SERVICE BULLETIN

NO. FAS-036

MODIFICATION OF FRONT LANDING GEAR.

FA-200 Serial Nos 1 thru 101.

Figure 1. Front Landing Gear Assy (View Looking Aft)

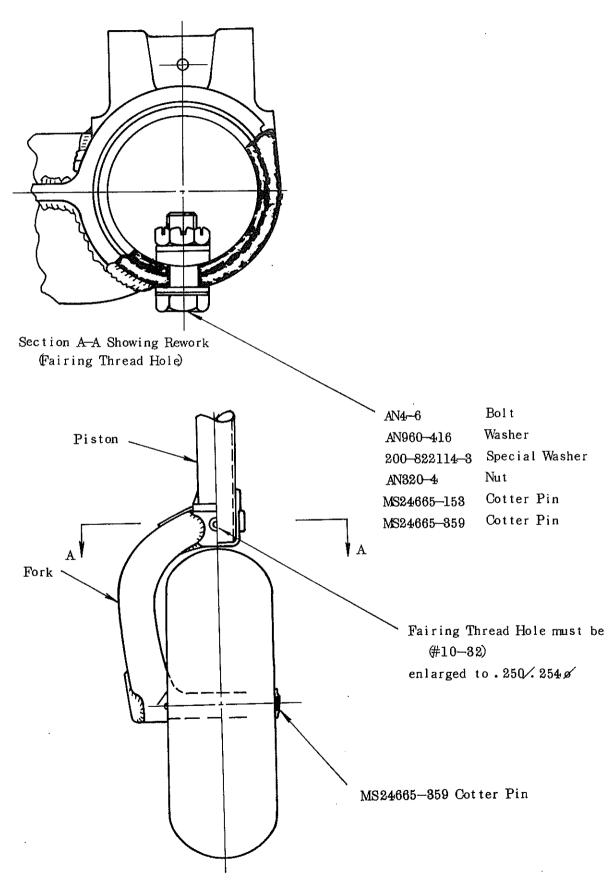
A hole to be installed in the thermal fitting portion of piston and fork of the subject assy.

- Jack up front landing gear, and remove tire.
 Using 1/4^b drill, enlarge the fairing thread hole to .250/.254^b.
- 2) Apply wet zinc chromate primer to the hole after removing burrs.
- 3) Insert hole, AN4-6, with washer, AN960-416.
- 4) Install special washer, 200-822114 -3, as shown in Figure 1. with its radius mated to radius of piston inside, and also install washer, AN960-416.

Torque nut, AN320-4, and secure with cotter pin, MS24665-153.
